Planning Application 21/2758/FUL

With reference to Document 'Design Access Statement Seating Slide' (3446995.pdf)

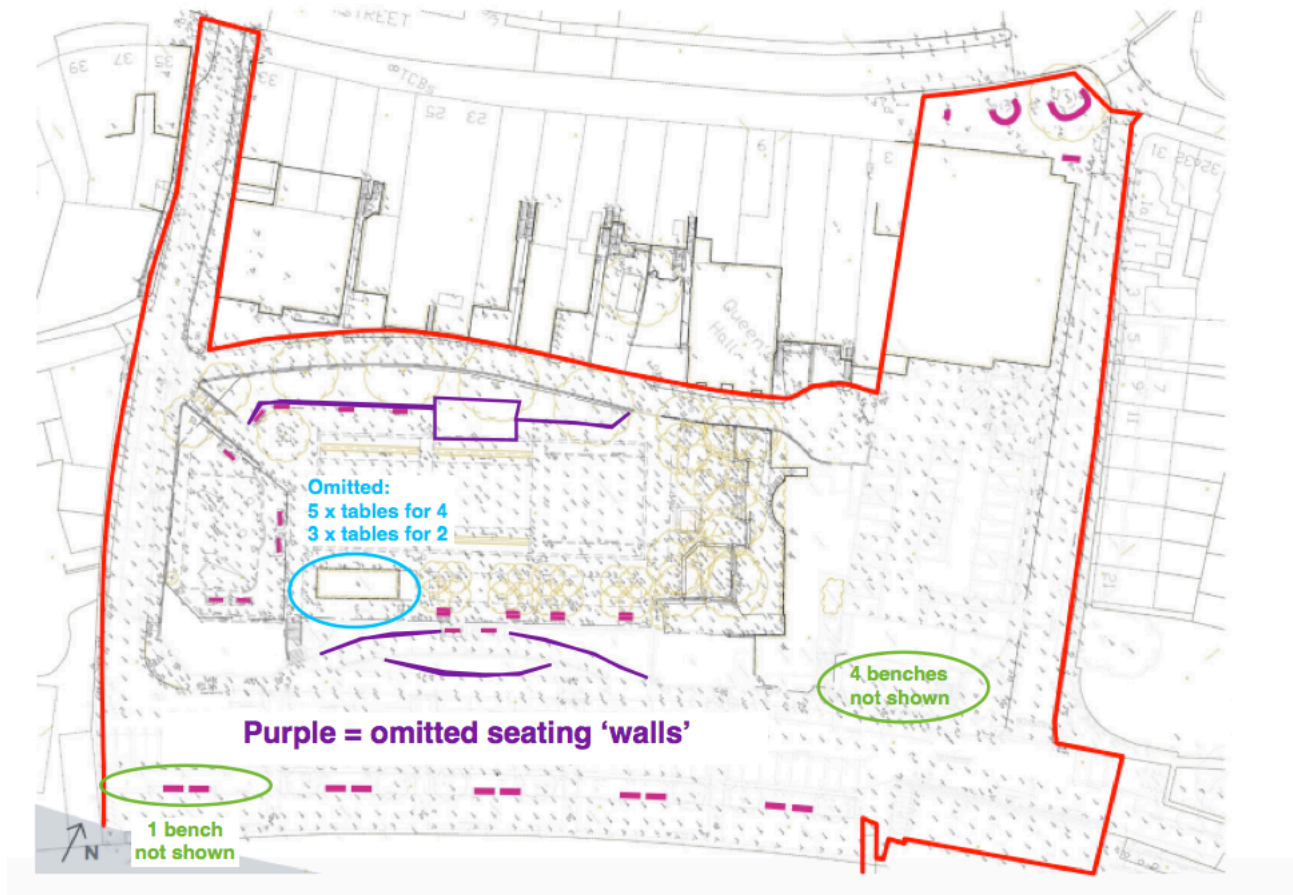
The Existing Seating on the Development site has not been accurately represented.

Five benches have been omitted, along with substantial sections of 'seating wall' to include the raised seating area around the edge of the sandpit.

The outdoor seating of Sunshine Cafe has also been omitted - 5 tables that seat 4 people, and 3 tables that seat 2 people.

Marked in purple on the image above (taken from the above referenced slide) are the areas of seating wall/raised seating around sandpit that have been omitted, along with the location of 5 benches (in green) that have also been omitted.
